September 2017

**SUBJECT: Urgent Field Safety Notice. S-ICD programmer software version 4.04 addresses two previous Field Safety Notices (ref. 10000038388 and ref. 92127890)**

## Appendix A – Identification of S-ICD Programmer Software

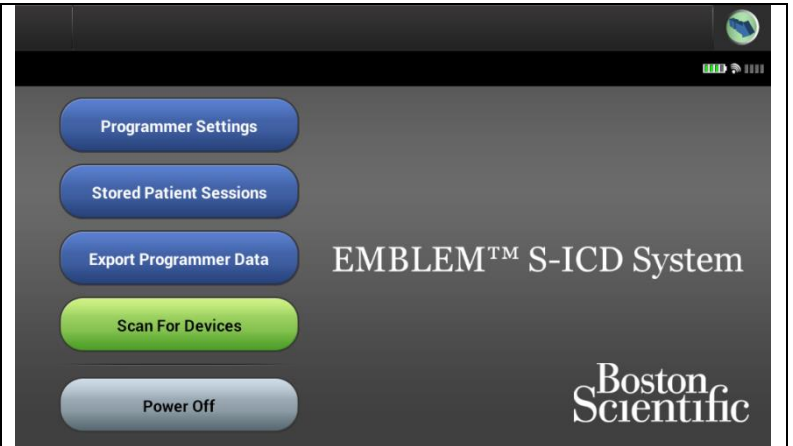
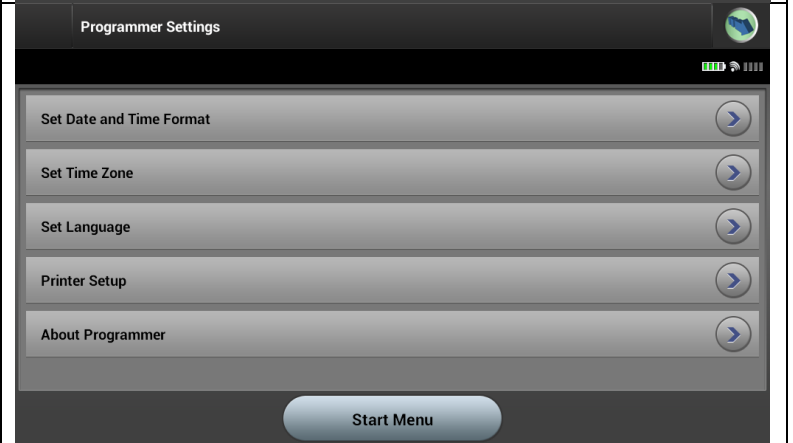
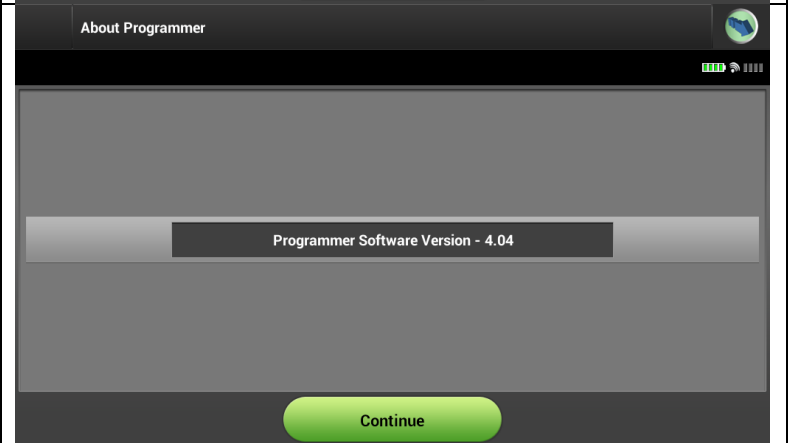
<p>1. Select Programmer Settings</p>	
<p>2. Select About Programmer</p>	
<p>3. Software that is version 4.04 or higher addresses this behavior for S-ICDs</p>
